Engineering Report for Zoning and Platting Commission Hearing
Peaceful Hill Condominiums
Application: C14-2011-0141

May 20, 2012
Engineers Letter
Peaceful Hill Condominiums
Traffic, Number of Units and Drainage Issues
Application: C14-2011-0141

Figure 2: Peaceful Hill Sample Lot Layout

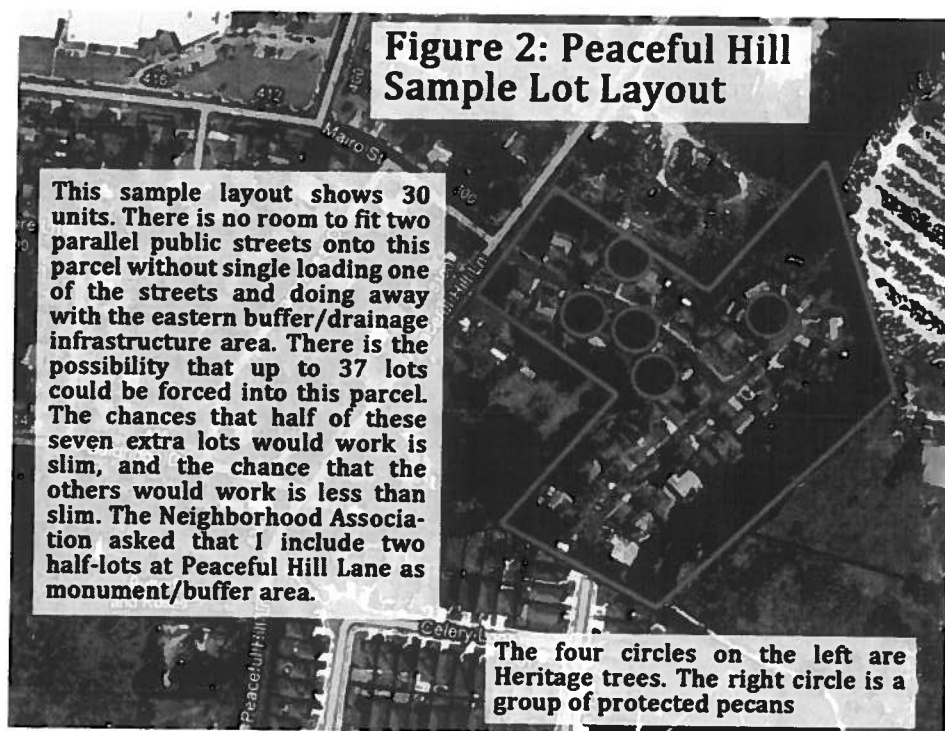
The SF-2 land use designation of 5,750 square feet per lot, assuming 20% (+/-) for roadways and drainage infrastructure, is only a starting point in any evaluation of the number of lots that a particular parcel can accommodate. Once this is determined, additional land must be removed from the assumption for complicating factors due to parcel shape, terrain and critical environmental features. In the case of this tract, all three of these complicating factors conspire to reduce the number of units that can be constructed on this specific parcel as described below and in Figure 2:

The parcel has an exceedingly odd shape. It is too narrow to allow for two parallel public streets creating a loop at any point, so a simple "T" street layout must be assumed. This reduces the number of lots.

There are four heritage trees on the site. These trees are located so that several to numerous lots cannot be constructed, reducing the number of possible lots further.

The parcel is quite flat and there is no alternative for underground connection of storm drain sewer lines. This means that the stormwater facilities cannot be constructed in deep ponds with a small surface area and must instead utilize shallow ponds with large surface area(s). Additionally, there is no defined drainage leading off the property and flow spreaders must be used to return stormwater discharge to its natural sheet flow condition. This requires more land area and further reduces the number of units that can be placed on the site.

I have prepared an example site layout (see below), using cut and paste (Google Maps) lots from the adjacent Peaceful Hill neighborhood that demonstrates these things.

This layout includes 30 lots. The lots were physically cut and pasted from the Peaceful Hill neighborhood. Accurate measurement of the actual size of these lots is shown in Figure 3 and is found to be 12 percent larger than the minimum lot size for SF-2 of 5,750 feet.

As figure one shows, there is not enough room to provide for a public street loop under SF-2, with houses on both sides of the street. There is enough room for a loop with houses only one side of half the loop, but all lots in the loop must be an odd size; approximately 75 feet x 75 feet and there is no room for drainage facilities on the downhill side, much less a buffer between this parcel and the adjacent parcels.

When the buffer(s) and room for drainage infrastructure are added in, even a loop that is half "single-loaded" is infeasible. The only way a loop is feasible is SF-6 zoning and a site plan using 3,750 sf "condo lots."

If all of the above assumptions and negotiations were successful, and two highly undesirable flag lots were added in the triangle, the lot count would be 37 or 38. In reality the lot count will likely end up at *no more than* 33 lots or 3.5 lots per acre if the tree survey and negotiations work out favorably for the developer.

Figure Two shows about 50 to 75 feet of vacant land to the east and south of the sample lots. This area is for stormwater facilities and flow spreading. Unless stormwater is piped off-site (discussed below) discharge must leave the site as sheet flow and further, it must be discharge equally along all parts of the site where it would naturally be discharged.
